## Renishaw Co-ordinate Measuring Machines Product Division

### Product bulletin number: PBC- 02428

This bulletin is to announce the launch of the ACC2-3 controller for the ACR1 auto change rack.

Figure 1 ACC2-3

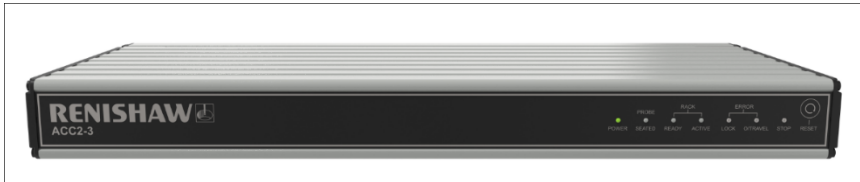
ACC2-3 has been designed as a direct replacement for ACC2-2. It is functionally backwards compatible with ACC2-2 and incorporates the same connectors and switches. ACC2-3 has been built with the latest design of controller enclosure, the 1U extruded aluminium enclosure used for all latest controllers. The ACC2-3 is now full width and not directly compatible with the 2/3rds width mounting of ACC2-2. Customers must take this into account when mounting the new controller.

ACC2-3 uses a separate 24V PSU instead of the 3-pin power lead used on ACC2-2. An XP Power VEC40US24 power supply will be provided with each ACC2-3.
